<p style="text-align: center;"> <small>• MANUFACTURERS OF WIPLINE FLOATS & SKIS • SPECIALISTS IN AIRCRAFT MODIFICATION</small> </p> <p style="text-align: center;"> <small>1700 Henry Avenue - Fleming Field South St. Paul, MN 55075 651-451-1205</small> </p>			Rev A
			Date 22-Mar-2007
Prepared by Ryan Nordell	Aircraft Make / Model AT-802	Float / Ski Model Wipline Model 10000 Amphibious	Page 1 4
FAA Reviewed <input checked="" type="checkbox"/>	Title AT-802 Asymmetric Scoop Position Indicator Upgrade		
ALL INFORMATION IN THIS SERVICE DOCUMENT BASED ON FAA APPROVED DATA

SERVICE KIT: 71

EFFECTIVITY: AT-802 aircraft with Wipline Model 10000 floats S/N 10003 to 10052

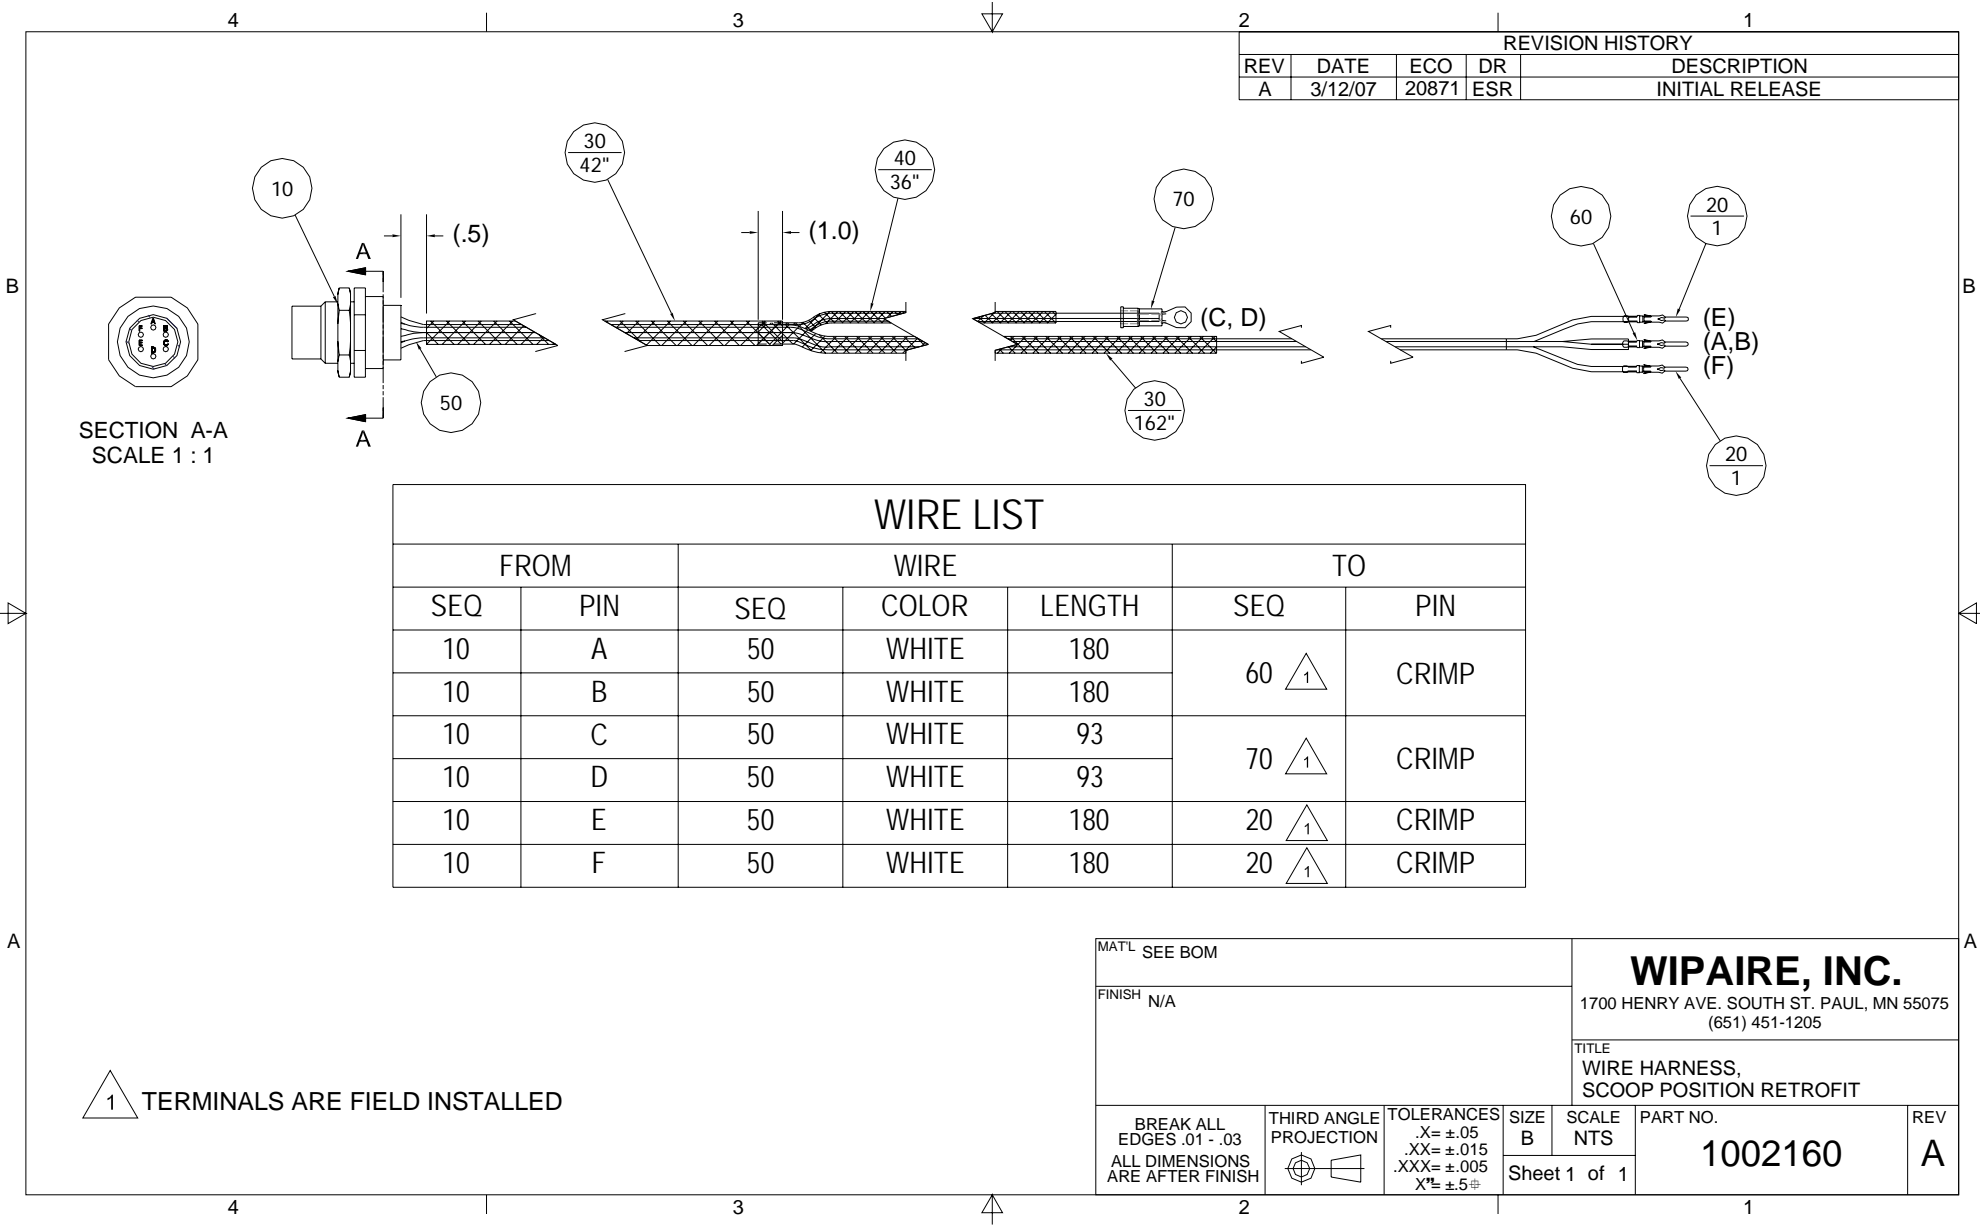
10. Un-pin pins 7, 8 and 9 on the existing harness at plug P4 (Left hand side), and P5 (Right hand side) inside the fuselage. Terminate and stow the wires these pins were on. Route the retrofit harness to the respective plug (P4 & P5). Trim wires and crimp the terminals on the retrofit harness wires as per print 1002160

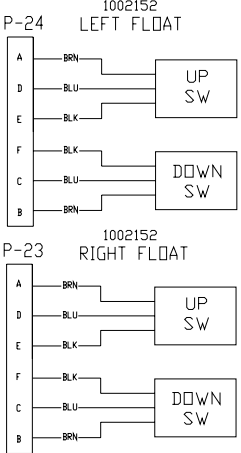
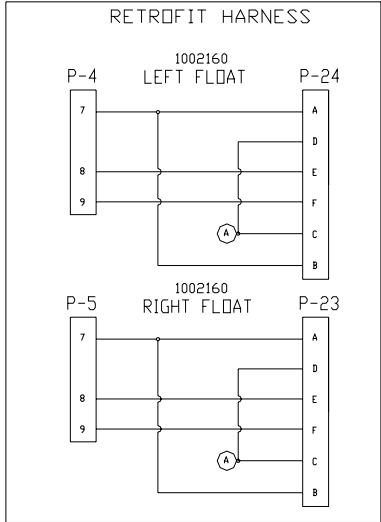
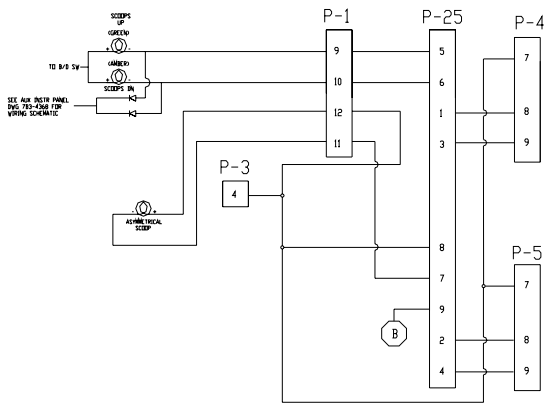
11. Insert pins into 7, 8 and 9 on plug P4 & P5 per drawing 1002265.
12. Actuate the probes to check proper positioning of the magnetic switches and adjust the position of the switches if needed.
13. Reinstall and seal all covers removed in step 1 and reinstall foam tank.
14. Repeat steps 1-12 for other float.
